1. **Case # 15-002 Chamberlain Woods Final Subdivision:** The Board will review and take action regarding a Final Plan Major Review application, submitted by Coastal Buildings and Investments, Inc., for the development of an 9-lot residential subdivision, a 225 foot private drive, and associated site improvements, on a 7.22± acre parcel with frontage on Barrows Street and the end of Boody Street. The proposed subdivision is located in the Town Residential 5 – Columbia Avenue – Spring Street (TR5) Zoning District. Assessor's Map U27, Lot 6.
2. **Zoning Ordinance Rewrite Committee (ZORC) Update**
3. **Approval of Minutes**
4. **Other Business**
5. **Adjourn**

**DRAFT Findings of Fact
Major Development Review
Final Subdivision Plan
May 5, 2015**

Project Name: Chamberlain Woods Subdivision
Case Number: 15-002
Zoning: Town Residential 5 (Columbia Ave – Spring St (TR5))
Tax Map: Map U27 Lot 6
Applicant: Coastal Building and Investments, Inc.
141 Pleasant Street
Brunswick, Maine 04011

I have reviewed the final plans from Sitelines sent via email on April 1, 2015 and offer the following comments:

FIELD WK: BWM	SCALE: 1"=40'	SHEET:
DRN BY: RPL/JJM	JOB #: 1019.01	C4
CHD BY: CYN	MAP/LOT: U27/6	
DATE: 01/19/15	FILE: 1019.01-SITE

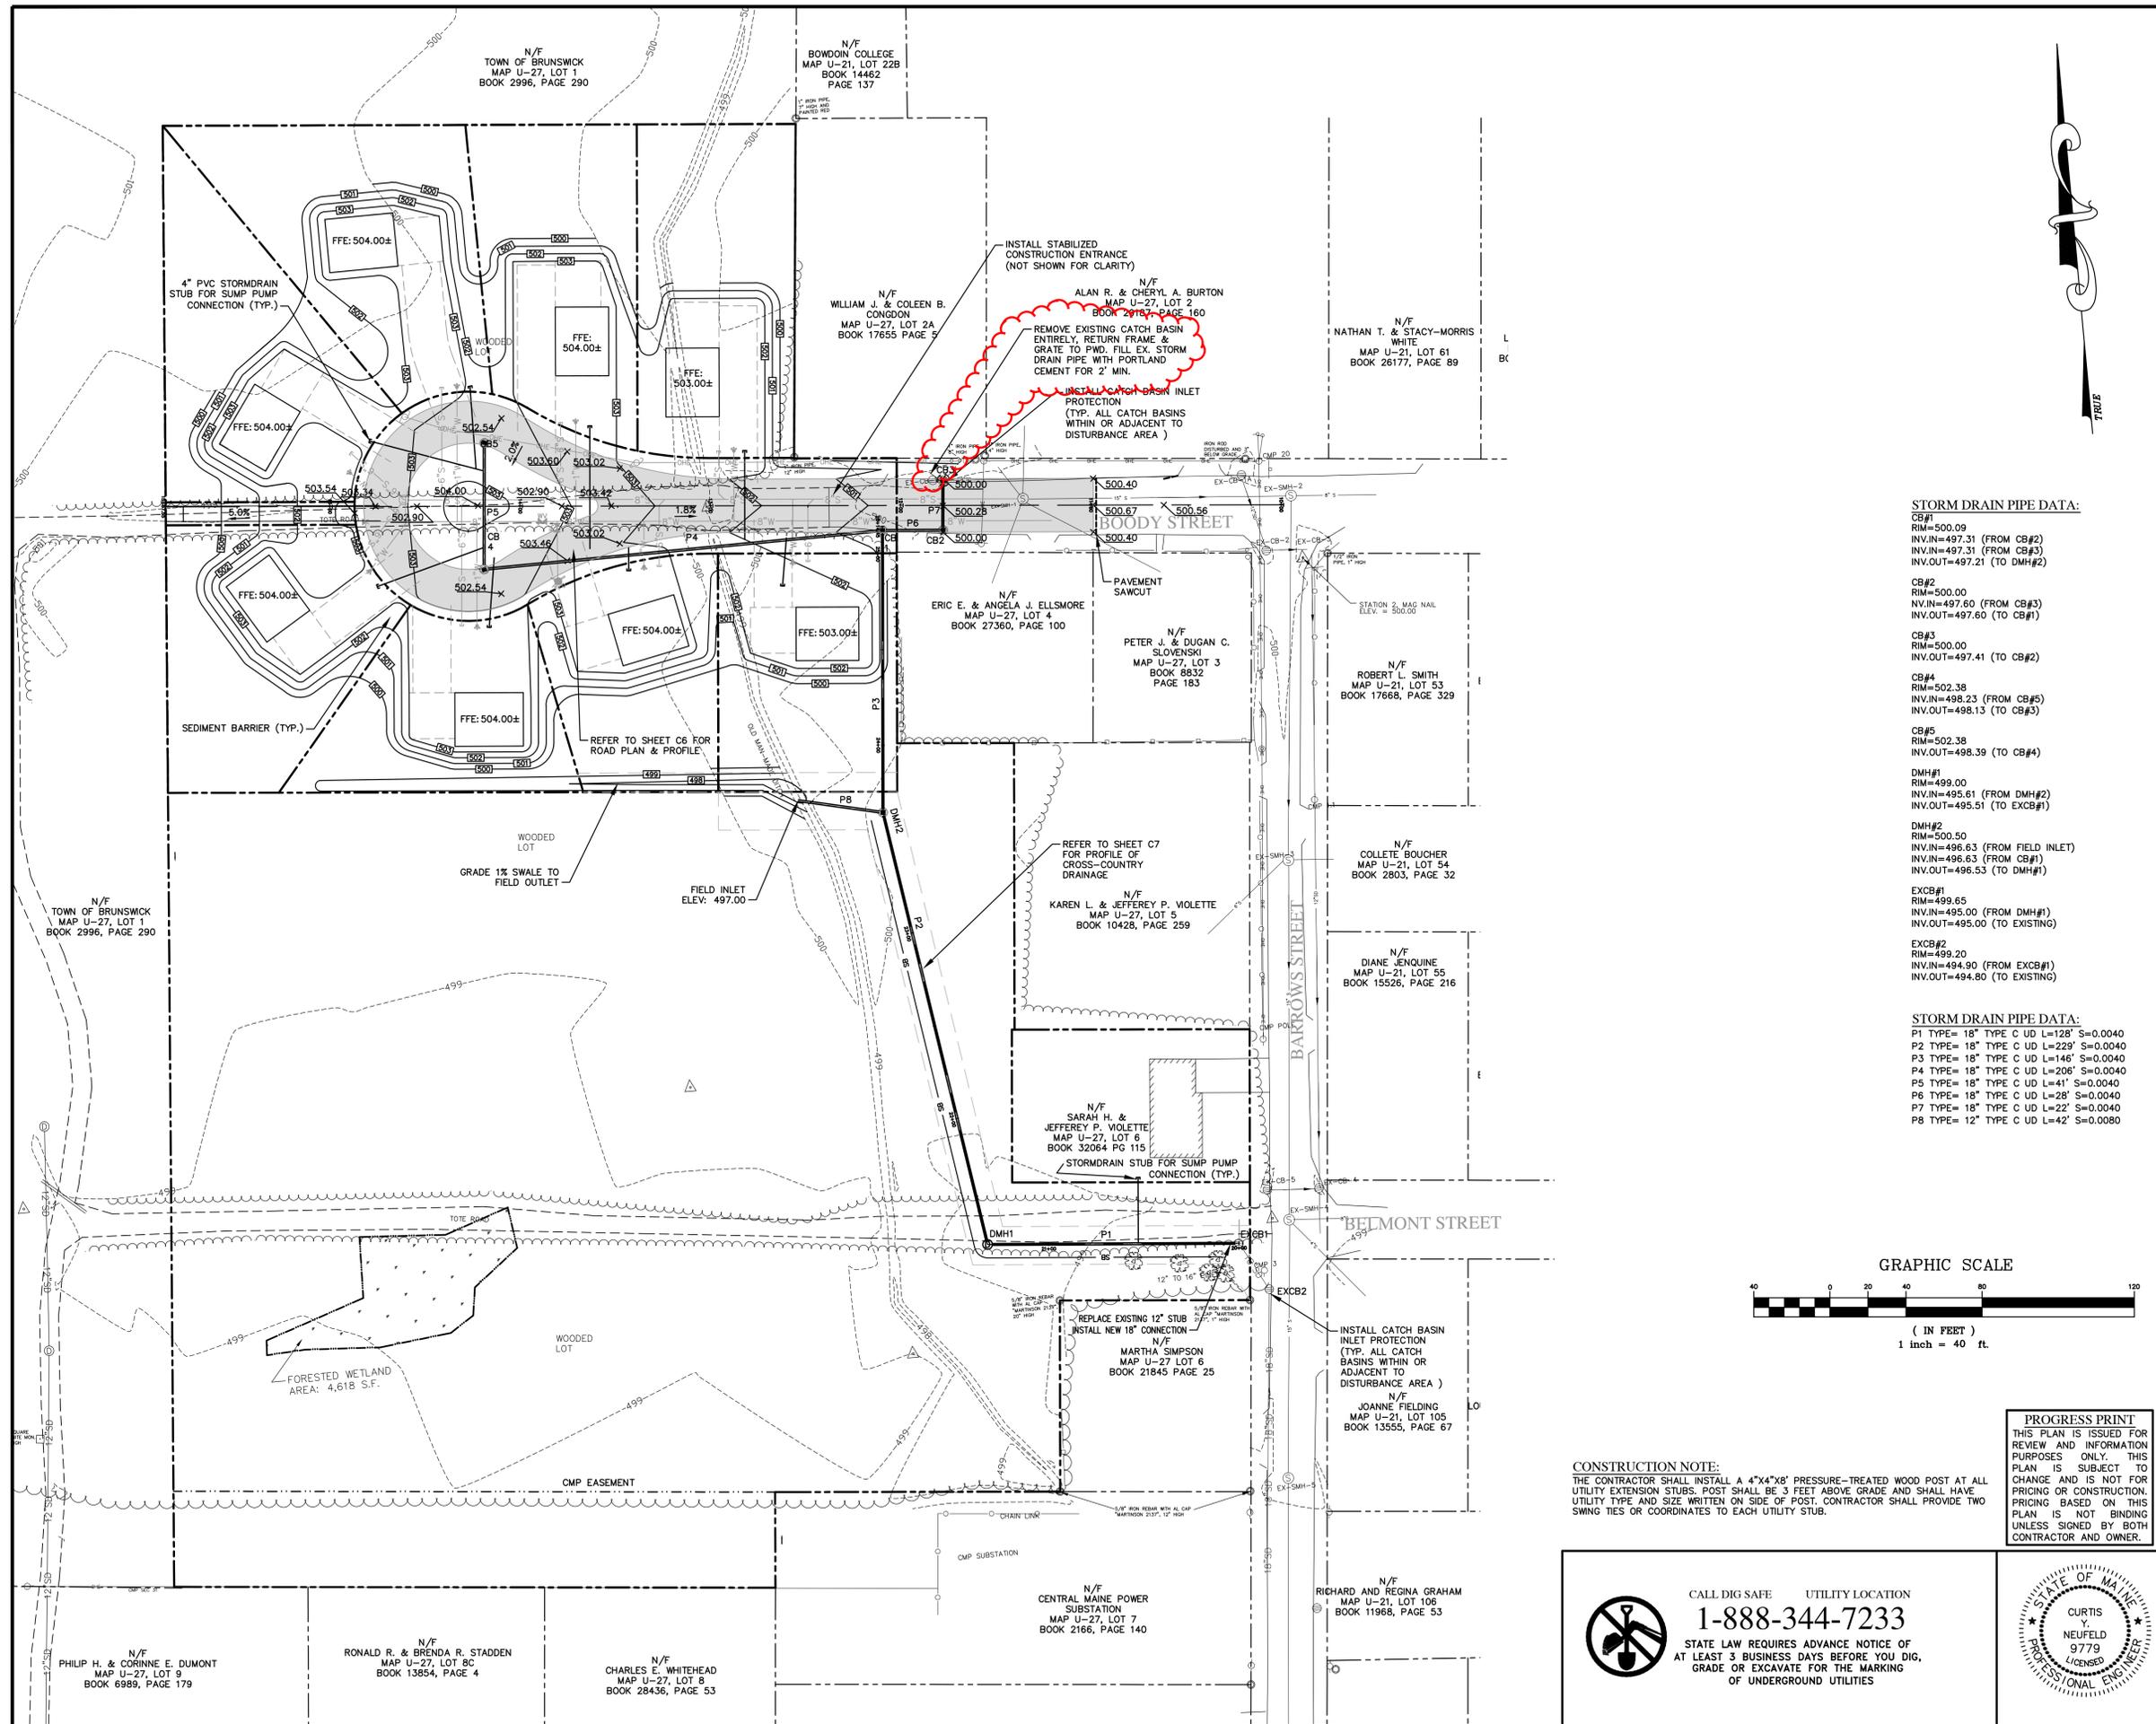
2. The proposed town storm drain easement is now shown with an appendage connecting to Lot 9 and I am not sure why the town needs that as part of the public drainage easement. On sheet C4 it is indicated a stub out will be provided to serve the sump pump for Lot 9 so the easement/connection is to benefit Lot 9 then it should be an easement that is conveyed to them and not the town as we don't want any maintenance jurisdiction for their lot connection. This issue needs to be clarified.

3. On sheet C4 a field inlet (pipe run P8) is shown from DMH2 and we don't object to this connection but it has been drawn on private property to be retained by the developer and outside the proposed storm drain easement. We will need the easement extended in this area to allow our maintenance of this pipe. It was also my understanding a drainage easement encumbering the development of lots 1, 3

2. The proposed town storm drain easement is now shown with an appendage connecting to Lot 9 and I am not sure why the town needs that as part of the public drainage easement. On sheet C4 it is indicated a stub out will be provided to serve the sump pump for Lot 9 so the easement/connection is to benefit Lot 9 then it should be an easement that is conveyed to them and not the town as we don't want any maintenance jurisdiction for their lot connection. This issue needs to be clarified.

3. On sheet C4 a field inlet (pipe run P8) is shown from DMH2 and we don't object to this connection but it has been drawn on private property to be retained by the developer and outside the proposed storm

4. On sheet C4 new CB3 is proposed and it will replace an existing catch basin. The plans need to indicate the developer's contractor is responsible for completely removing the existing catch basin, salvaged frame and grate to be delivered to Public Works and the existing storm drain lateral pipe to be abandoned sealed for at least two feet with Portland cement concrete.

The easement has been adjusted / revised to ensure the Town of Brunswick has access.

A note has been added to the plan as indicated.
